**EAST HARTFORD-GLASTONBURY
ELEMENTARY MAGNET SCHOOL PHASE 2
GLASTONBURY, CONNECTICUT
STATE PROJECT NOS. 054-0095 MAG/N/PS & 054-0096 MAG/N/PS
GLASTONBURY BID NO. GL-2011-04**

The following changes to the Drawings and Project Manual shall become a part of the Contract Documents superseding previously issued Drawings and Specifications to the extent modified by this Addendum No. 4. Bidders shall ensure this addendum is acknowledged in the appropriate space provided on the Bid Form when submitting their bid.

NEW CONCRETE SLAB TO EXIST. CONCRETE SLAB DETAIL

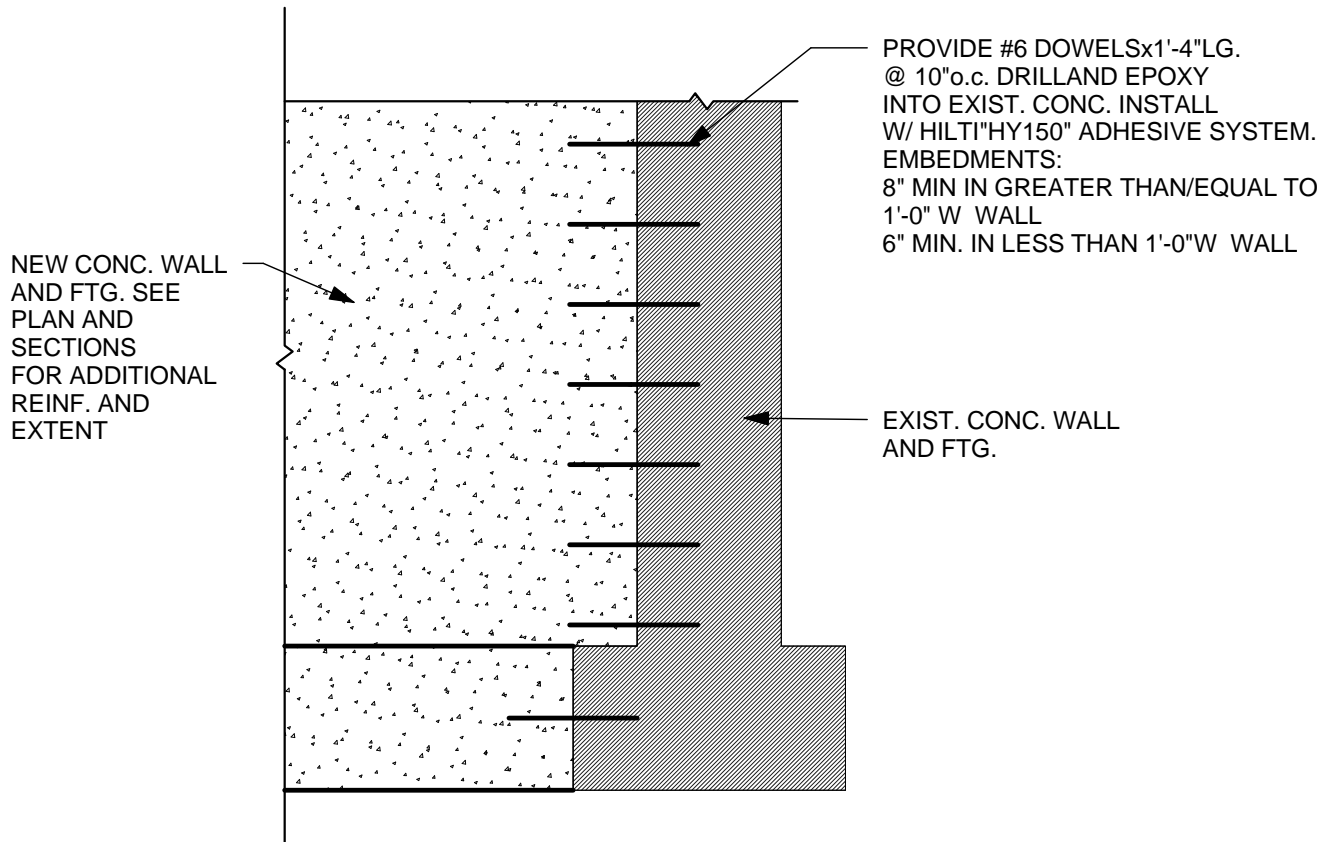
- RESPONSE:**
- 1) See S100.2: Dimensions shown to corner of foundation wall at approximately B.7-12.2.
 - 2) Verify existing footings in the field. If new footing encroaches on existing footing, use dowels as shown in attached Sketch SSK-1.
 - 3) See answer to #2.

PROVIDE #6 DOWELSx1'-4"LG.
@ 10"o.c. DRILLAND EPOXY
INTO EXIST. CONC. INSTALL
W/ HILTI"HY150" ADHESIVE SYSTEM.
EMBEDMENT 6" MIN..
